## CONTRACT ADDENDUM

ADDENDUM NO.: 001

**Revised Bid Proposal Form for Addendum 1 - Dalton Project No. PW-2021-COVIE**  
**COVIE RIDGE REGIONAL DETENTION POND & STORMWATER IMPROVEMENTS PROJECT**

PRELIMINARY  
GRADING  
AND  
DRAINAGE  
PLAN

DATE	9/15/2020	DRAWING NO.	C9
PROJECT NO.	20-020

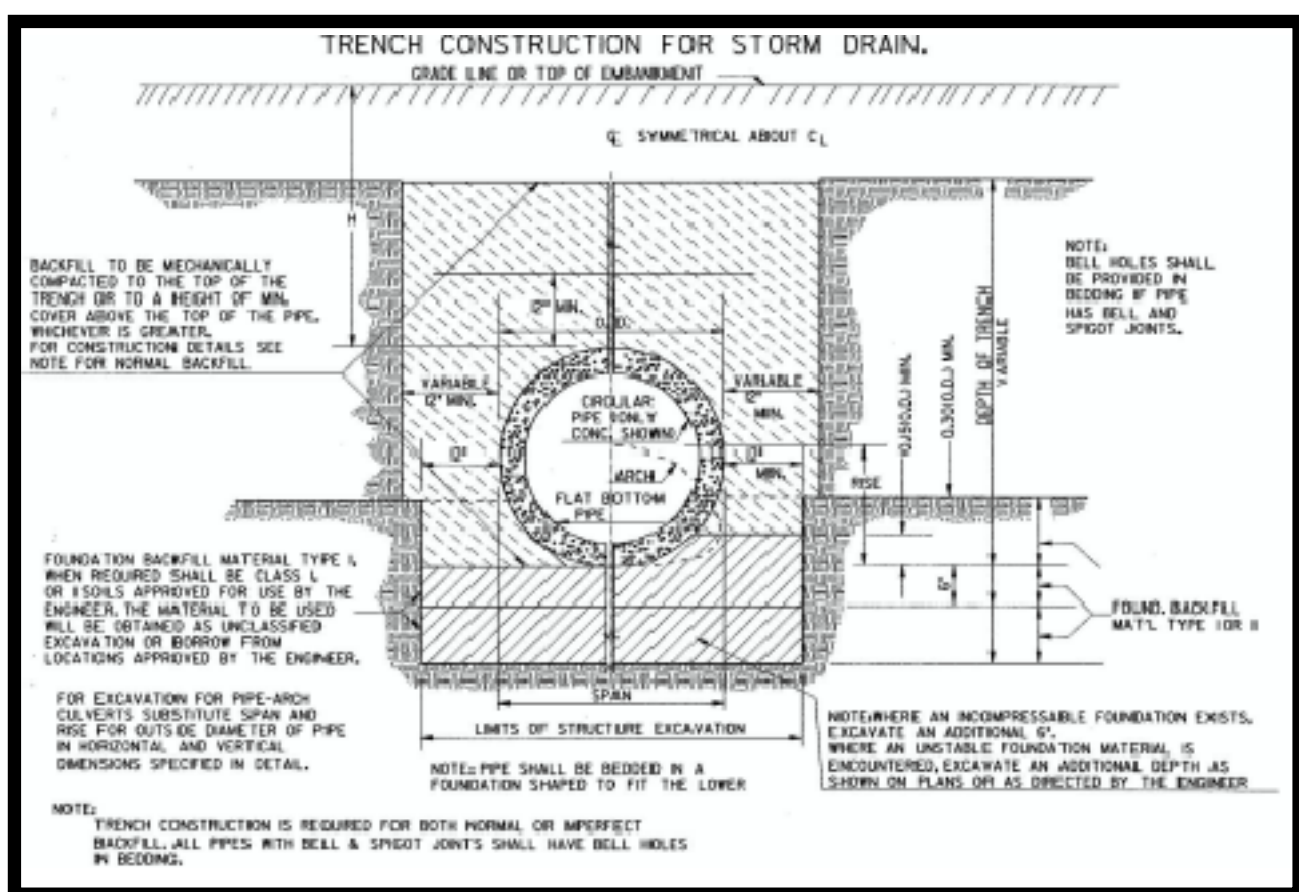
2. Sheet C9: Construction Note 2 and Construction Note 3 have been revised. The City of Dalton **will not** be providing a borrow pit for suitable dirt or for clay material. The Contractor will be responsible for securing these items from permitted borrow pits. Please see the revised sheet C9 attached to this document.

- ALL MATERIALS SHALL MEET GDOT STANDARDS AND ALL MATERIALS SHALL MEET GDOT STANDARDS AND SPECIFICATIONS.
- IF CUT MATERIAL IS NOT SUITABLE FOR USE IN THE BERM, THE CONTRACTOR WILL BE RESPONSIBLE FOR SECURING THE ADDITIONAL MATERIAL FROM A PERMITTED BORROW PIT. THE CITY OF DALTON WILL NOT BE PROVIDING A BORROW SITE NOR BORROW MATERIALS FOR COMPLETION OF THE PROJECT.

- THE CONTRACTOR WILL BE SOLELY RESPONSIBLE FOR LOCATING AND SECURING THE CLAY MATERIAL FROM A PERMITTED BORROW PIT. THE CITY OF DALTON WILL NOT BE PROVIDING A BORROW SITE NOR BORROW MATERIALS FOR COMPLETION OF THE PROJECT.
